MEMORANDUM

TO: Town of North Castle
FROM: Eliot Senior P.E. L.S.
SUBJECT: Sir John's Plaza
DATE: April 26, 2021

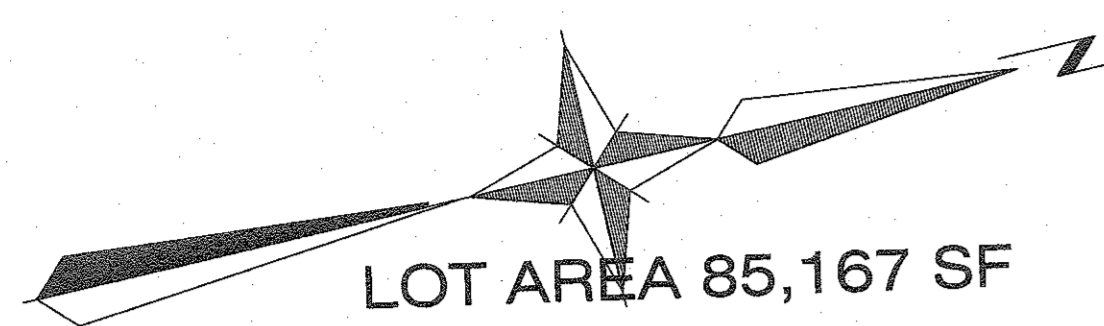
9. The plan should indicate where the Safety Post Detail is to be applied.

Safety posts by compactor shown

D-1

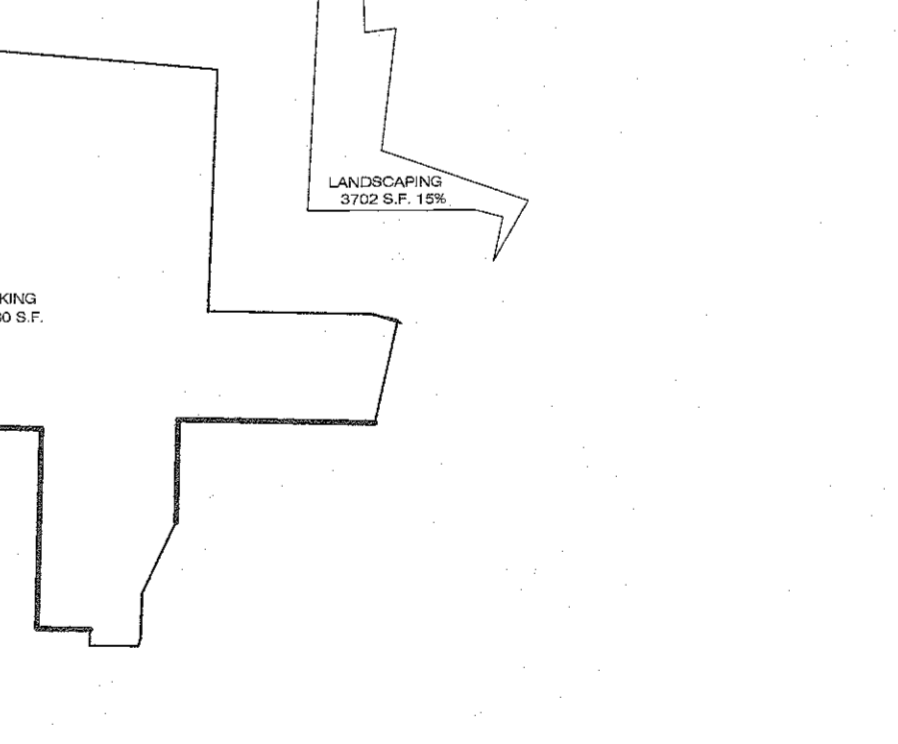
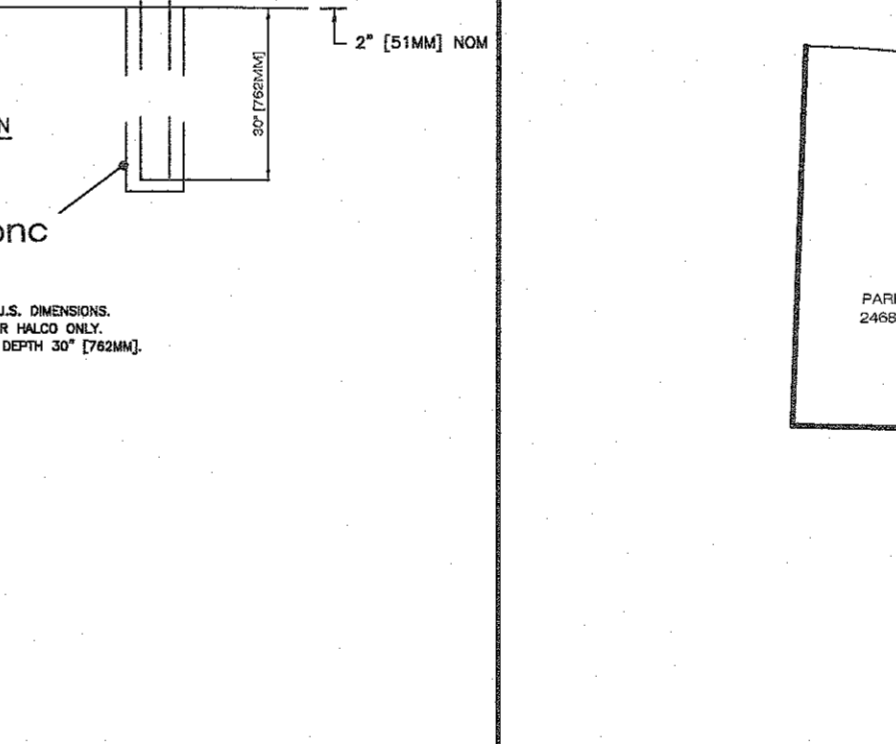
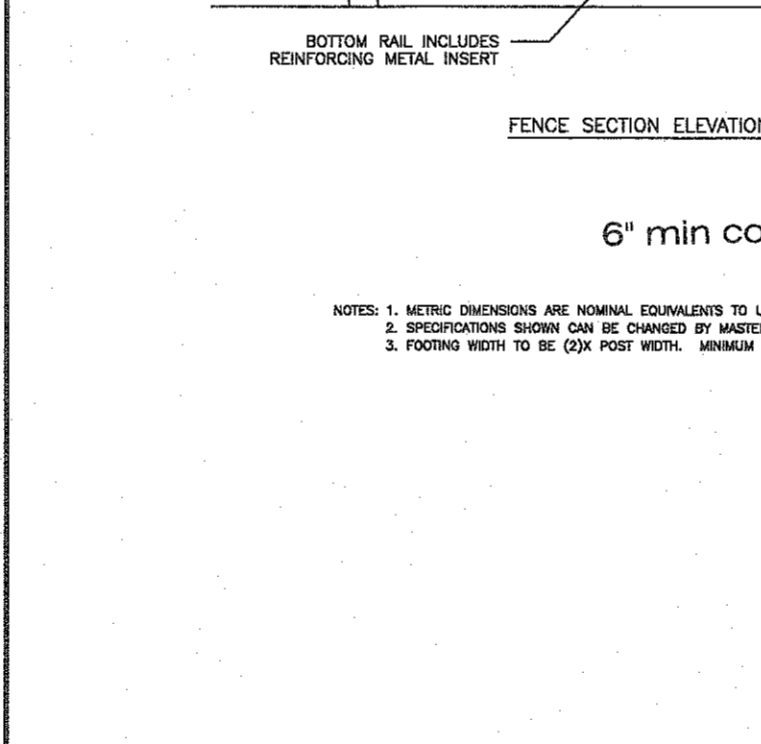
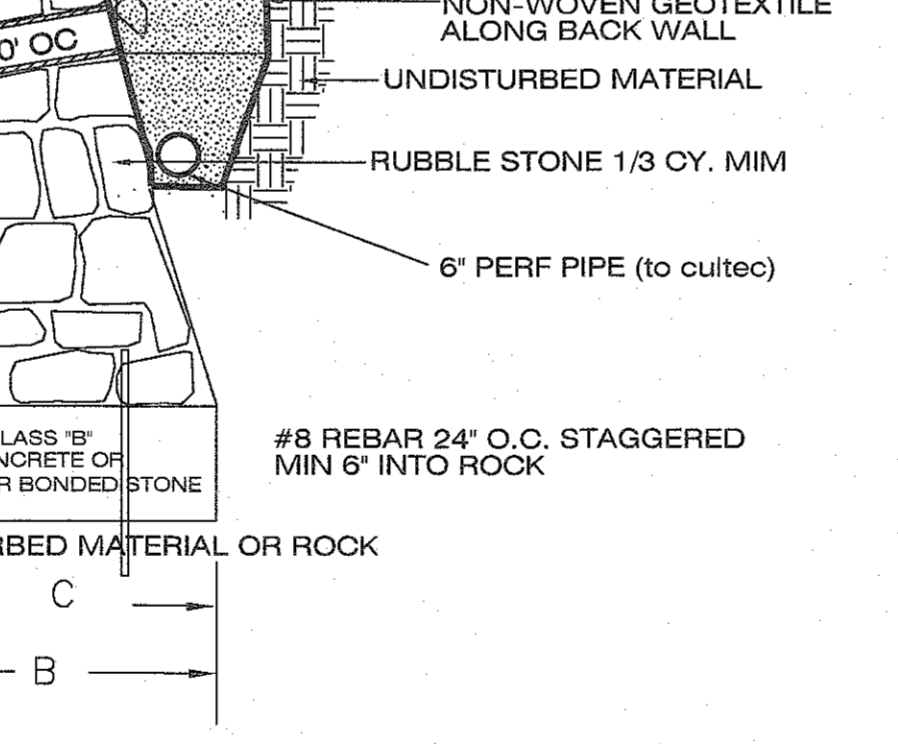
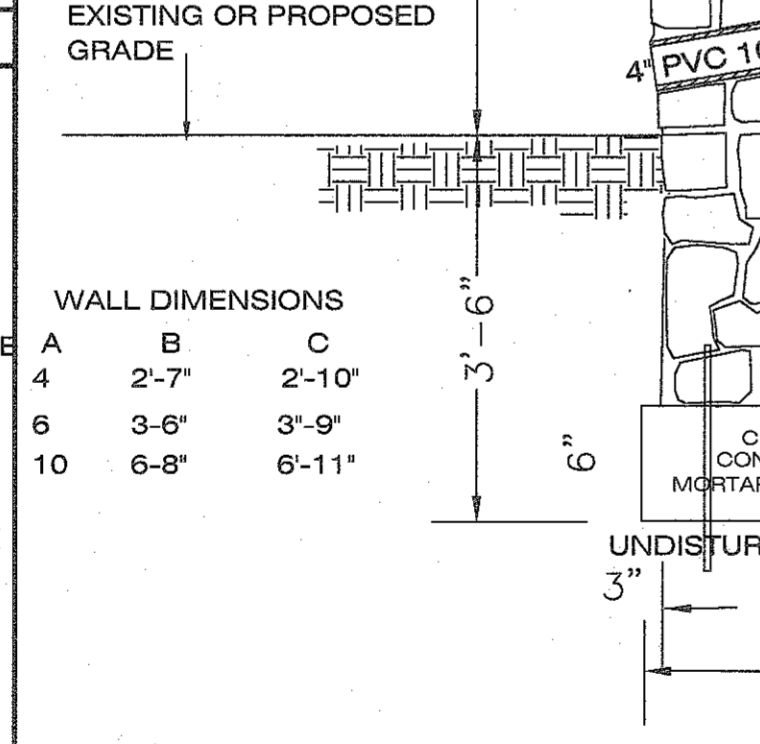
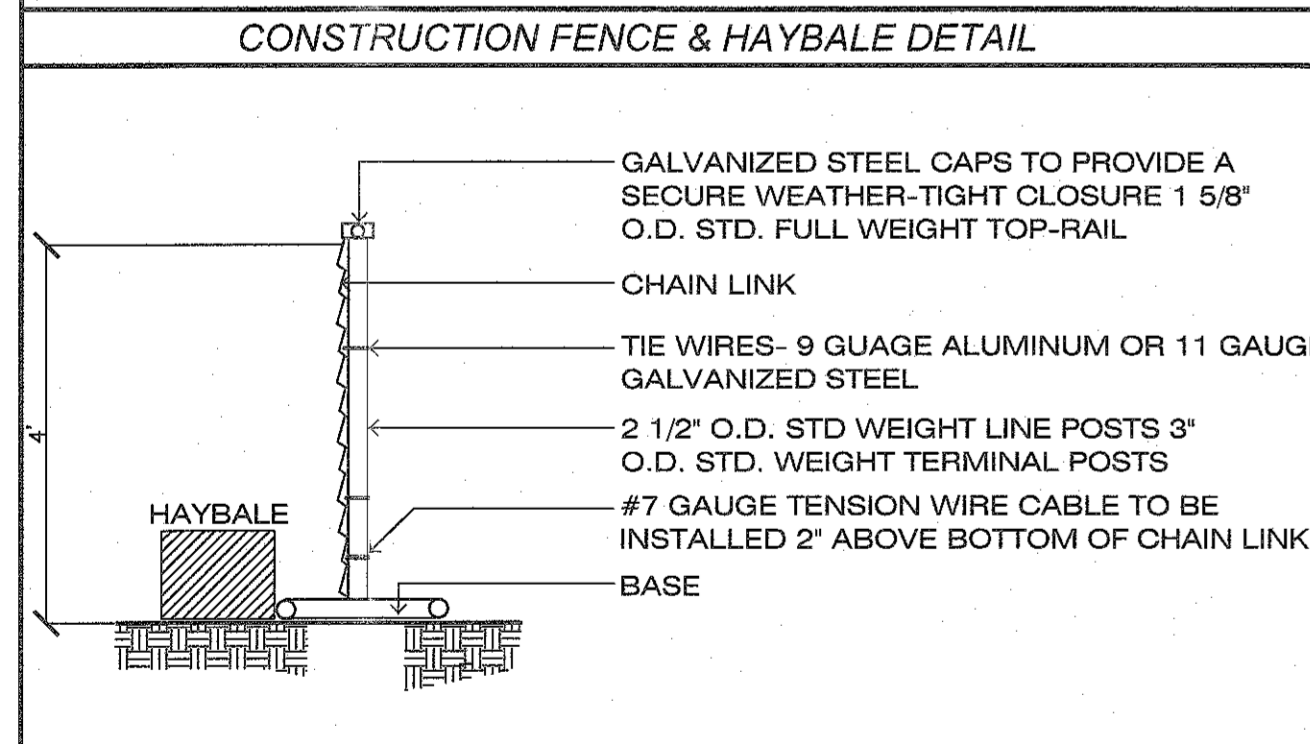
5. The Geotechnical Report indicates that the rock along the western border of the parking lot appears to be of good quality and that no rock stabilization would be required. The Report, however, also states that a return inspection should be performed after additional cleaning and chipping of loose rock and soil was completed. The Report also recommends that steel netting or fencing along this section of the rockface be considered to retain any materials that may slide over time. Based on a site visit, the rock face in this section of the parking lot appears to be approximately 30 feet high with areas of loose rock and soil. Existing trees are also immediately adjacent to the top of the cut rock face. This office is concerned with the potential for loose debris and/or rock to fall into the parking lot, as well as the potential damage that could occur with fallen trees, on the slope, immediately above the rock cut. The applicant will need to provide additional detail regarding how this cut face will provide a safe and stable slope which may include, netting, additional tree removal, additional cleaning of the rock face, a short wall and fence at the toe of the slope, or combination thereof. We would recommend the Planning Board visit the site to get a better understanding of the current conditions and proposed retaining wall layout.

10. Foundation requirements for the proposed fence should be incorporated into the retaining wall detail.

A protective 5' high fence to be provided along western line of exposed rock cut. See plan and detail (D-1)

Fence details added. (See D-1)

IMPERVIOUS SURFACE

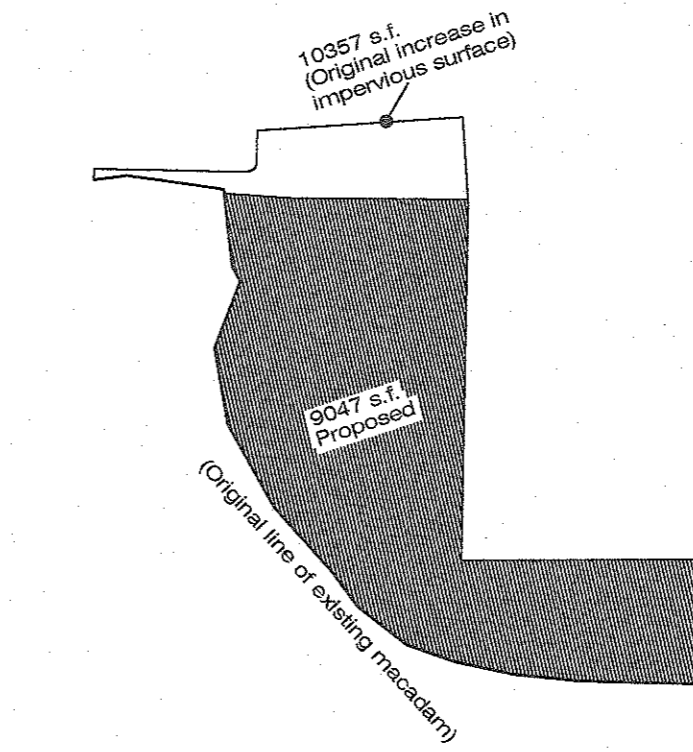
- 8 As shown on the Stormwater and Erosion Control Plan, it appears that the previous limits of disturbance will be expanded slightly for additional grading in the rear of the parking lot. We would assume that the majority of this parking lot will be resurfaced. The limit of disturbance illustrated on the plans should be updated accordingly.

Disturbance area has been revised. Actual impervious surface has decreased. (See D-2)
